ADDENDUM No. 1

RFP No. 23-04

Broadway Street Water Main Replacement and Resurfacing Project

STANDARD CASTING SCHEDULE SD-GU-4

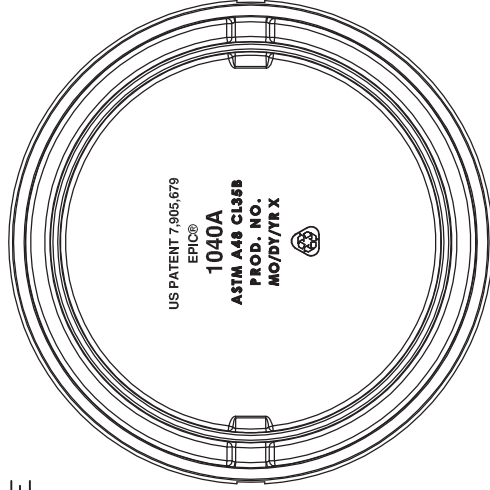
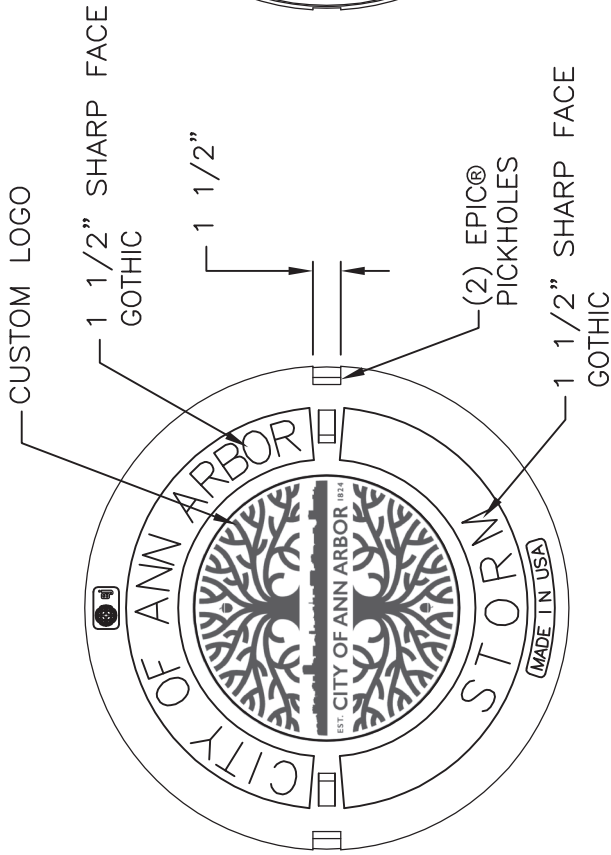
City of Ann Arbor Casting Schedule and Logo Special Detail

SCALE: NTS
DRAWING No. 2020030-11
SHEET No. 11 OF 50

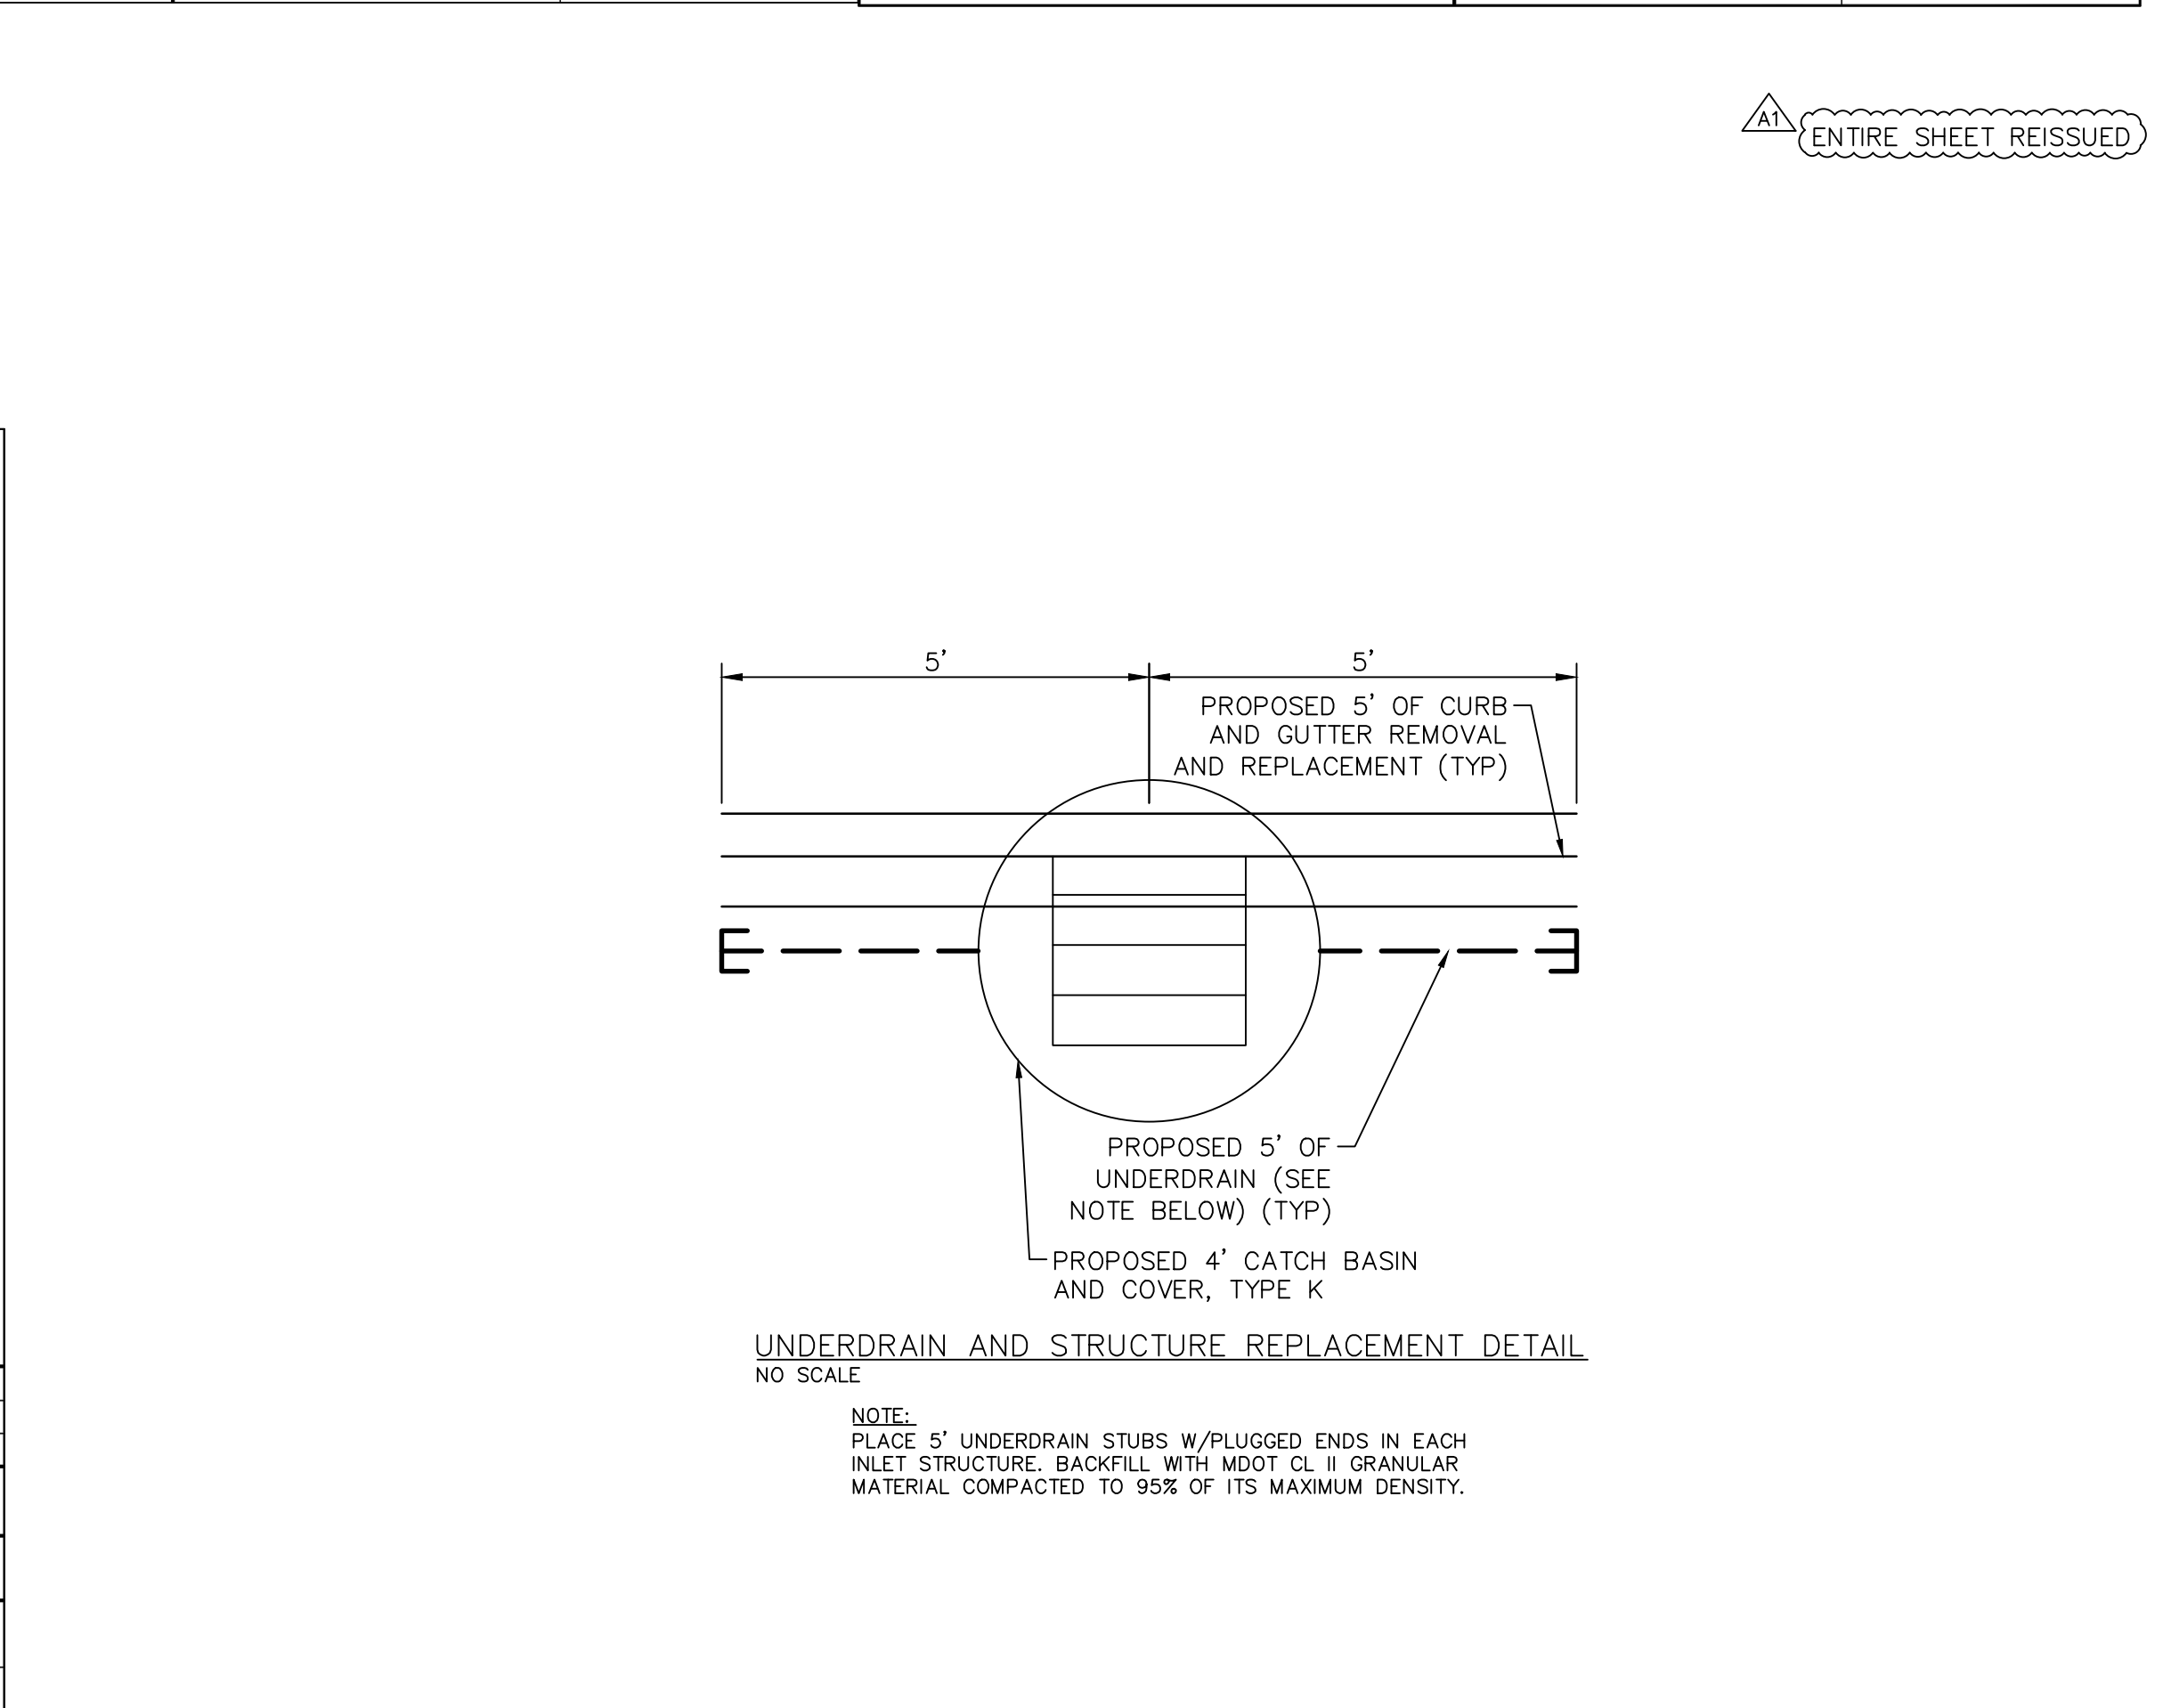
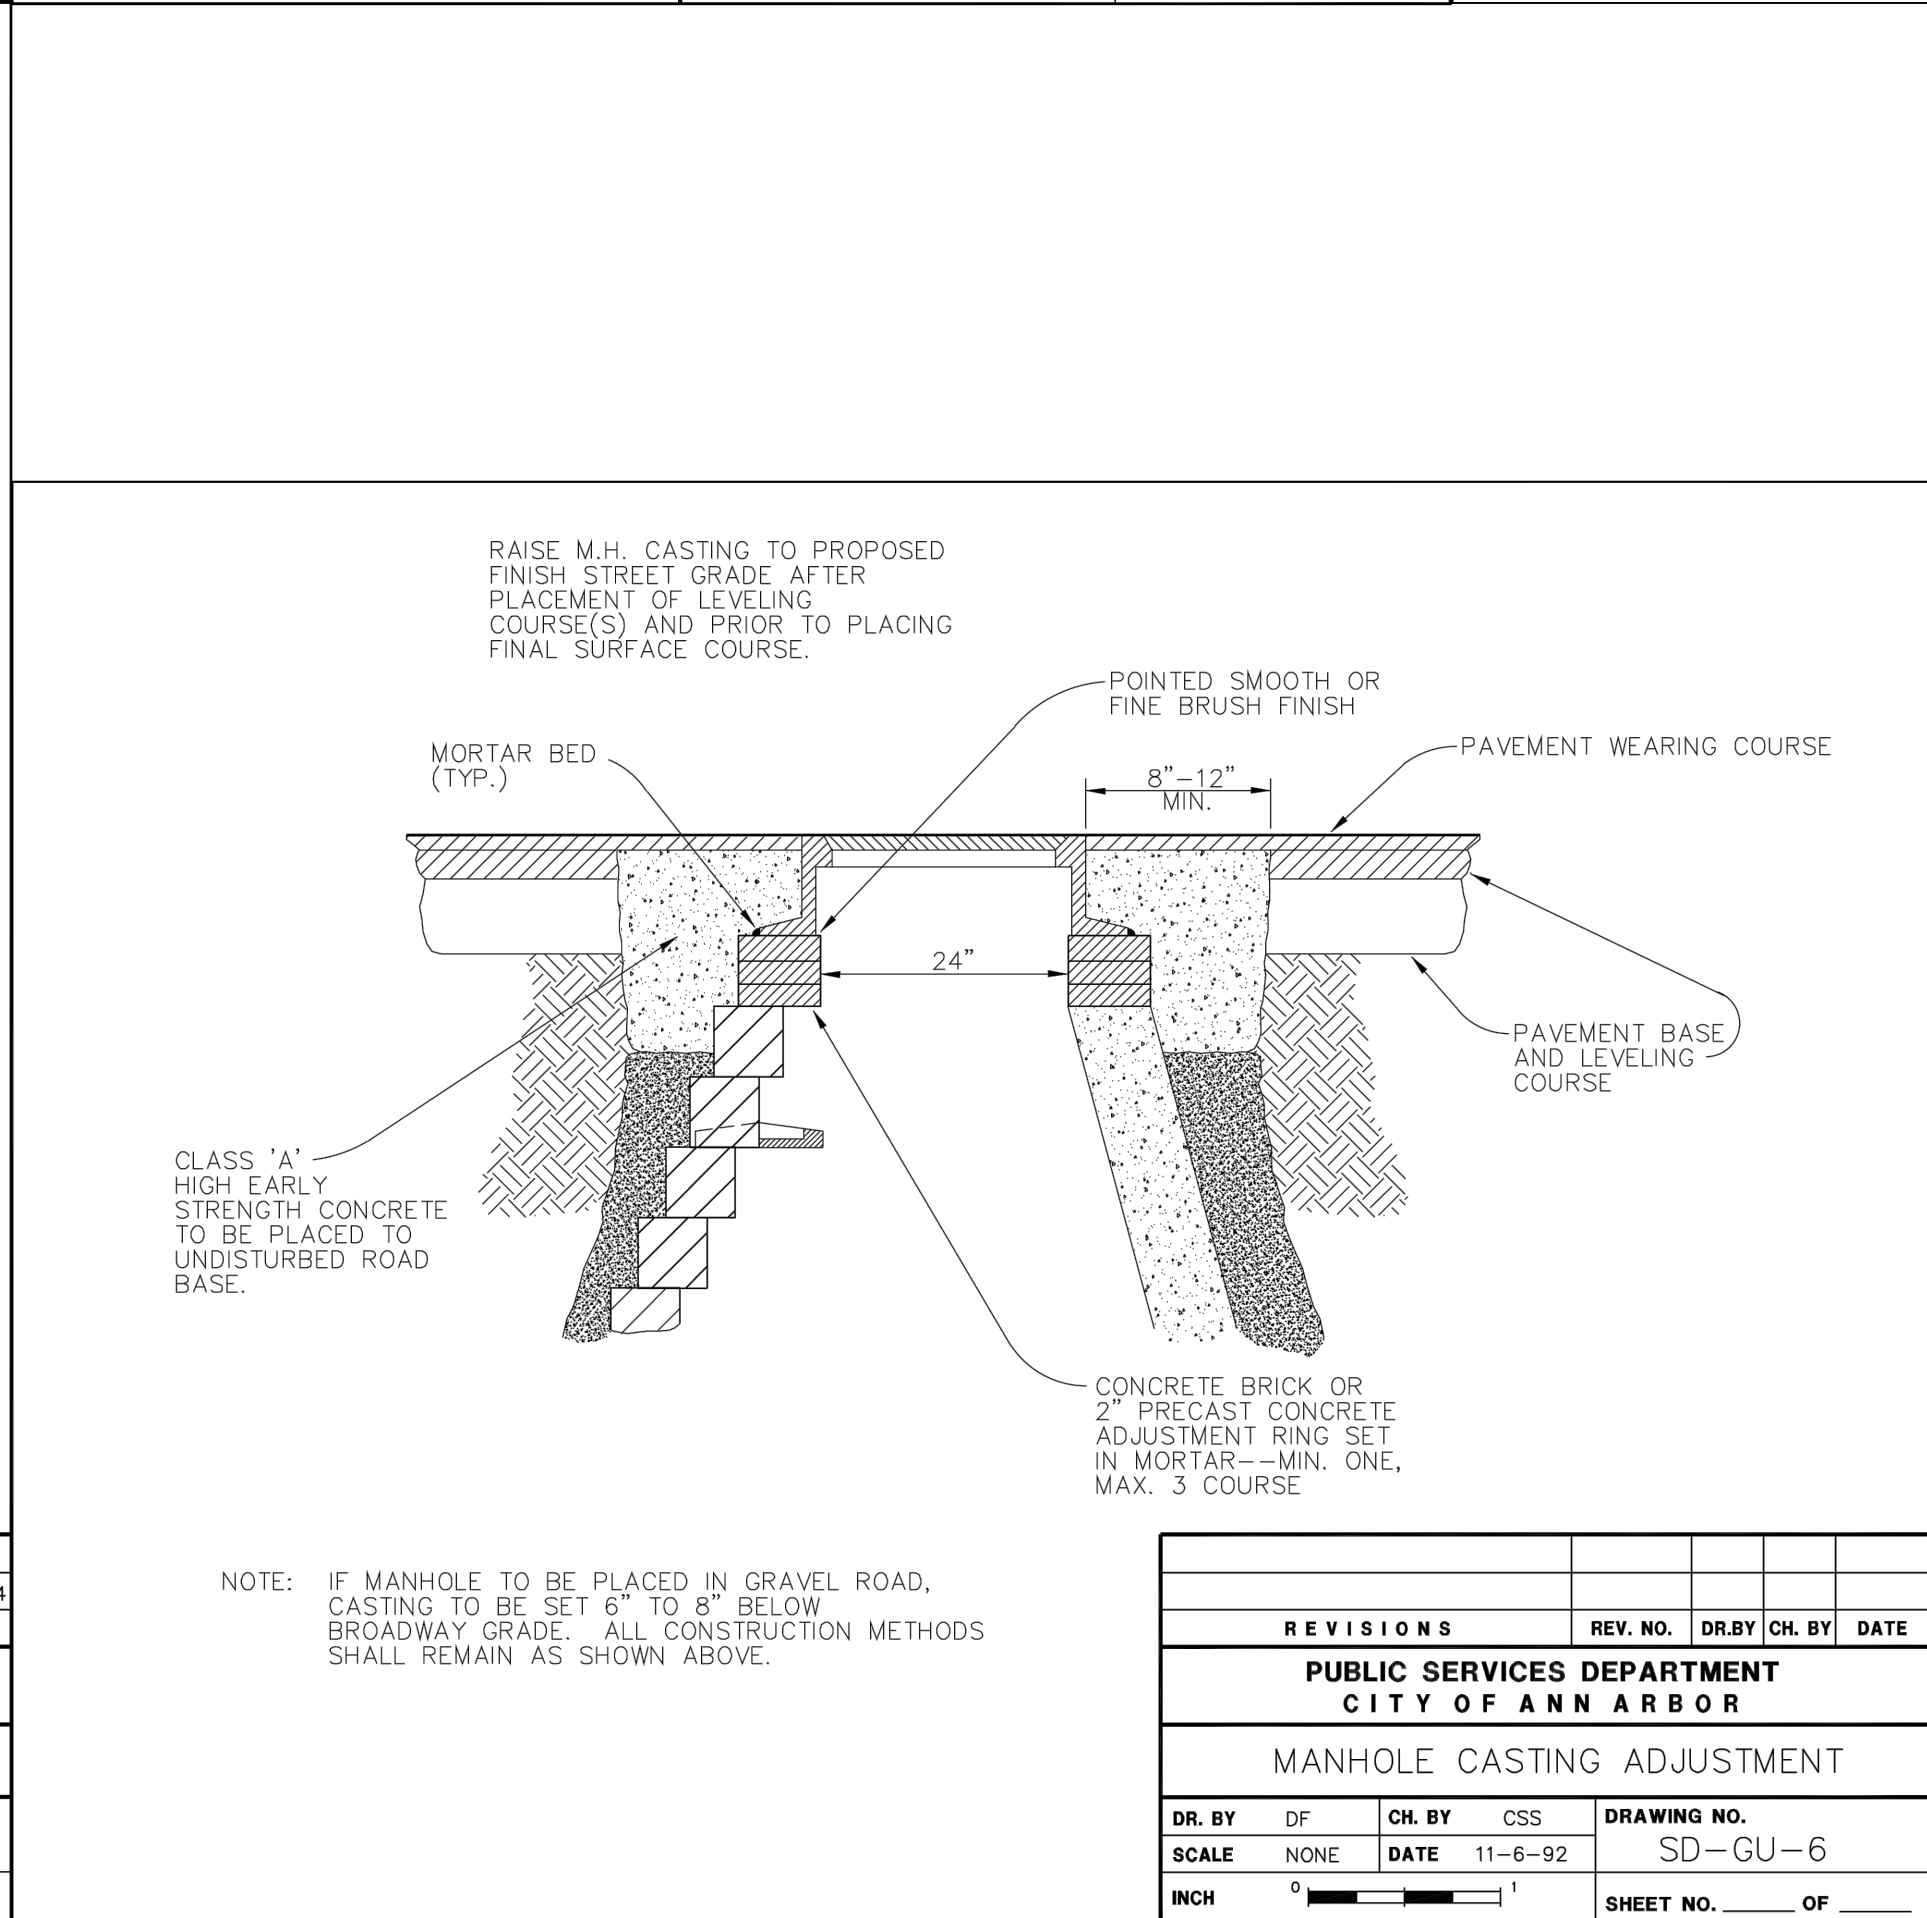
Section/Page(s)	Change
Replace Plan Sheets 11-12	Revised Standard details.
Replace Plan Sheets 15-18	Revised sheets to include catch basins and storm leads Revised sheets to include update location of exiting gas main.
Replace Plan Sheets 31-35, 37, 39-41	Revised sheets to include catch basins and storm leads Revised sheets to include update location of exiting gas main. Revised sheets to include structure and sewer table
